**DANE COUNTY DEPT. OF  
PUBLIC WORKS, HIGHWAY &  
TRANSPORTATION**

# ADDENDUM

**RFB NO. 318048 - ADDENDUM NO. 4**

**CITY-COUNTY BUILDING FAÇADE JOINT REPAIR AND POWERWASHING**

## Modified Rain Screen (two stage joint sealants)

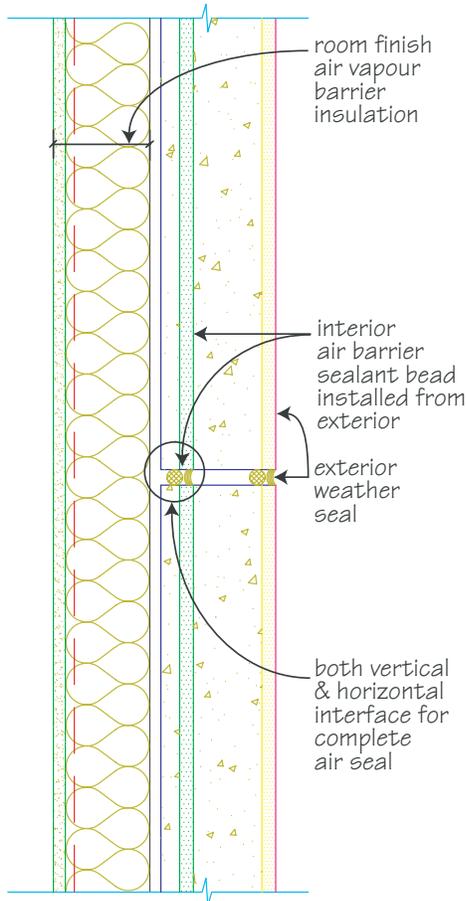
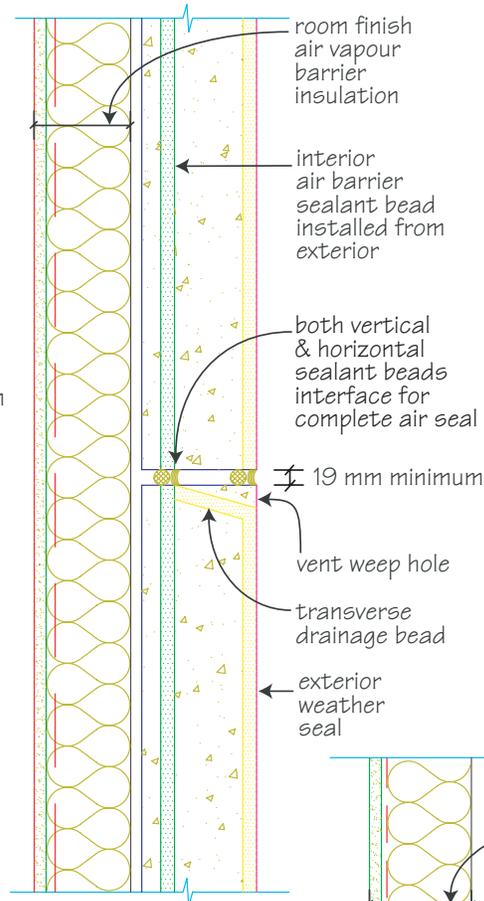
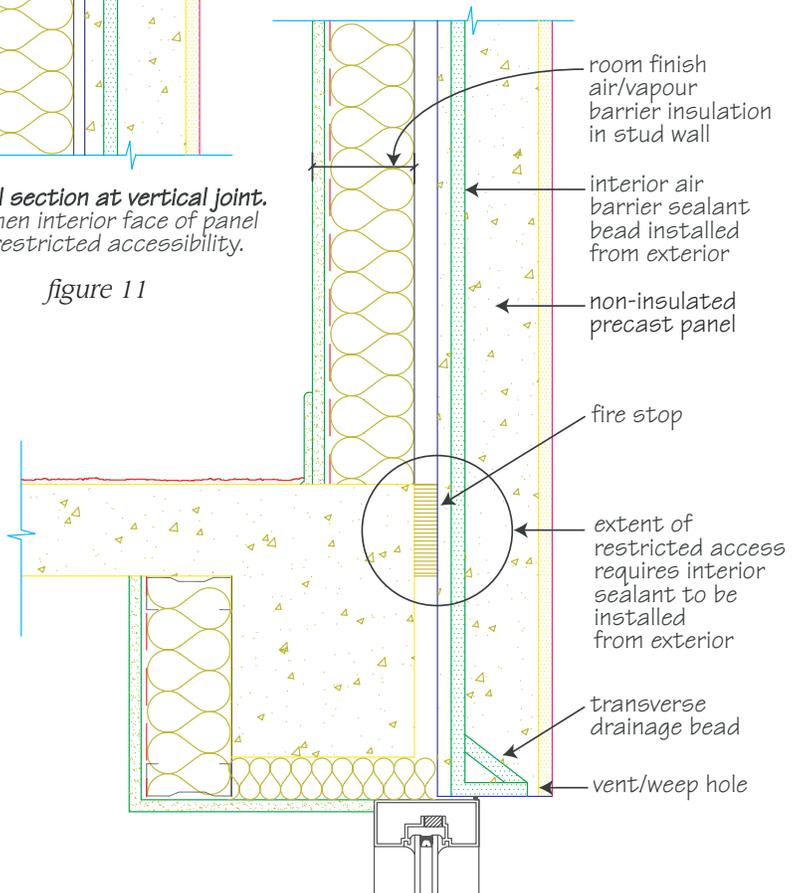
**14.** Is there a detail for the two stage sealant?

*Response: You are referred to “Architectural Precast-Concrete Sealant & Joint Guide”, pages 10-13 (attached), published by Canadian Precast/Prestressed Concrete Institute, available at www.cpci.ca.*
